Our Case Number: ABP-318607-23

Re: Proposed construction of a residential led mixed use scheme across 16 blocks within 9 buildings ranging in height from 4 to 15 storeys
Lands at Park West Avenue, Cherry Orchard Dublin 10. Bound by Cloverhill Road to the north, Cedar Brook Avenue and Park West Avenue to the east, Park West Cherry Orchard Rail Station to the southeast & the M50 to the west

Councillor Sophie Nicoullaud & TD Joan Collins observation

ABP Case number :318607

Figure 2.4 - Heights Diagram

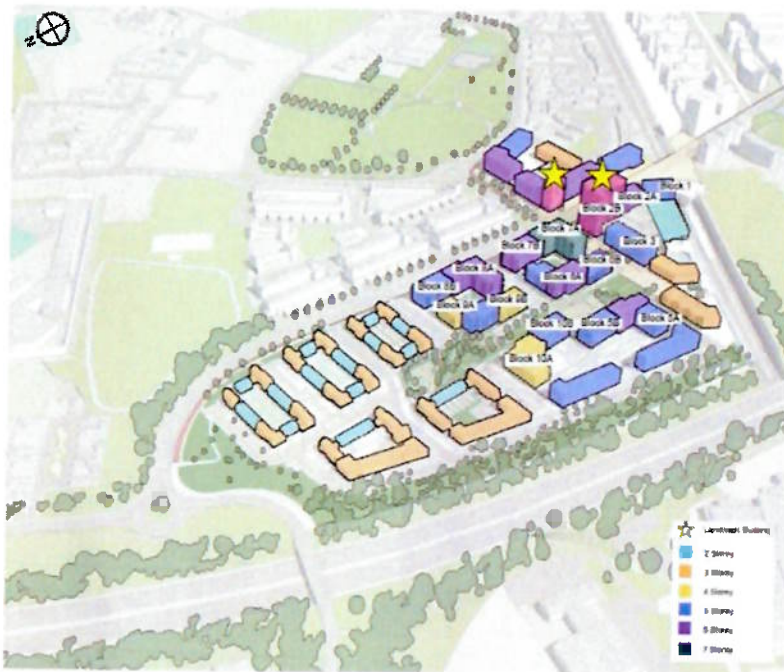
Figure 2 below has an inaccurate legend with pink colour missing any explanation and square representing building with no height details. The 2 landmark buildings have a yellow star are both pink in colour but one is to be a 15-storey building in phase 1 and the other it is unclear from all the various images and LAP and this proposal of what height it is proposed to be.

Figure 296. Shadow image on June 21st at 08:00 of Cedarbrook Apartments without Proposed Development (modelling software)

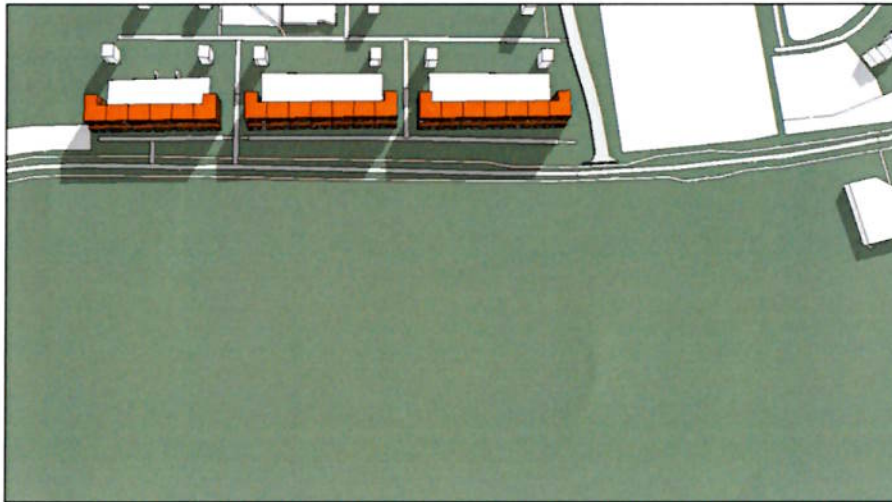
We are asking that accurate shadow images are provided of the plans before ABP makes a decision on the topic of natural light and shadows from proposed buildings. We are asking that the entire Cedar Brook complexes appear in the 3D drawing of the light study and not only the part of Cedar Brooks facing phase 1 and 2. We are asking that this light study include all the 4 phases of the entire Cherry Orchard Point project. on the 3 D drawing below, we can see that the entire shadow does not appear on the drawing: the shadow is not fully appearing between Cedar Brook and the proposed building 7 and 8. This omission is an obstruction to the real size and coverage of the shadow. This omission minimises the impact on the land of Cedar Brook and its building. This is not an accurate representation of the true impact of shadows created by the proposed buildings. It needs to be

The omission doesn't occur in the drawings without the proposed development as below
